**Pacific Gas and
Electric Company**

PG&E Letter DCL-00-098

Response to NRC Request for Additional Information Regarding License
Amendment Request (LAR) 99-03, Unit 1 Reactor Core Thermal Power Uprate

**PG&E Responses to Draft Request for Additional Information For
DCPP-1 Power Uprate (PG&E Letter DCL-99-170)**

Figure 1-1: Annular Fuel Pellet Dimensions

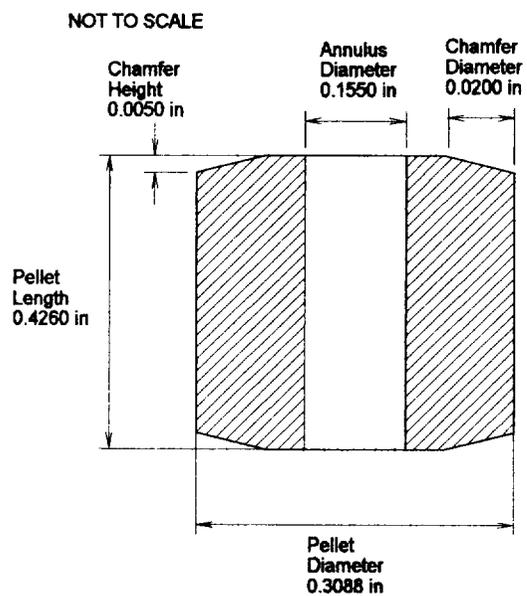
If the fully enriched annular fuel pellet blanket fuel design to be used for uprate reload is described in a separate report, provide reference to the topical report including the NRC safety evaluation.

Otherwise, provide: (1) a detailed description of the fully enriched annular fuel pellet blankets fuel design, including the lengths, diameters, and enrichment of the annular fuel blankets, the dimensions of the annular pellet blanket fuel and cladding, cladding material (ZIRLO or Zirc-4), and pre-pressurization, etc., and (2) the evaluation of this fuel design relative to Standard Review Plan (SRP) section 4.2, including the evaluations performed under DCPP-1 Uprating Program.

The fully enriched annular fuel pellet blanket design does not represent a new fuel design feature but has been in use at DCPP-1 since Cycle 9 (April 1997). The statement on Page 3-6 of WCAP-14819 (Enclosure B) refers to the fact that the annular fuel pellets are now being explicitly modeled in the small break loss of coolant accident (SBLOCA) analysis. Prior to this latest analysis, the potential effects of annular pellets on the SBLOCA results were conservatively bounded by applying a 10°F penalty to the calculated peak clad temperature (PCT). This statement should not be interpreted to indicate that the use of annular fuel pellets is being introduced for the first time in conjunction with the Unit 1 power uprate.

Axial blankets represent the top and bottom six inches of the active fuel region which usually

have a lower enrichment than nominal in order to optimize the fuel utilization in these outer regions of the core where the flux is less. The annular pellet blanket incorporates a cylindrical opening in the center of the pellet to increase the available volume inside the fuel rod to gain margin for the internal pressurization that occurs as a function of fuel burnup. The introduction of annular pellet blankets was provided as a supplement to WCAP-12610-P-A, "VANTAGE+ Fuel Assembly Reference Core Report," April 1995, Section J, which has been reviewed and accepted by the NRC. Annular pellet blankets are an integrated feature of the VANTAGE+ fuel design and are compatible with the cladding (currently ZIRLO) and range of pre-pressurization values associated with this fuel design. Annular pellet blankets may be designed with natural uranium (0.711 w/o), or uranium enrichment ranging from 2.5 w/o up to the fully enriched value of 5 w/o. The annular pellet blanket lengths remain the same, six inches at the top and six inches at the bottom as solid pellet blankets. The annular pellet dimensions are provided in the following, Figure 1-1.

The annular pellet blanket design feature was evaluated in accordance with 10 CFR 50.59 for the Cycle 9 core reload design using the NRC accepted reload safety analysis methodology in WCAP-9272-P-A, "Reload Safety Evaluation Methodology," July 1985. The evaluation concluded that the annular pellet blankets did not impact any non-LOCA, thermal hydraulic, or large break LOCA analysis results. These conclusions were based on fact that the analysis results were not affected by the explicit internal design of the fuel pellet, but used limiting heat flux and power distribution assumptions that were bounding for the calculated core design values. The evaluation did assign a 10 °F PCT penalty to the existing SBLOCA results to conservatively bound any potential impact of enriched annular pellet blankets until the Westinghouse model was revised to explicitly model this design feature. As discussed in more detail in Responses 14 and 9, Westinghouse and PG&E jointly generate and review the Reload Safety Analysis Checklist (RSAC) to verify that all applicable non-LOCA and LOCA reload safety limits remain bounding for the calculated core design values and including the effects of enriched annular pellet blankets. In summary, a topical report was not submitted to the NRC and the Unit 1 uprate license amendment request does not include a safety evaluation specifically for this fuel design feature, since it was already incorporated into the licensing basis under 10 CFR 50.59.
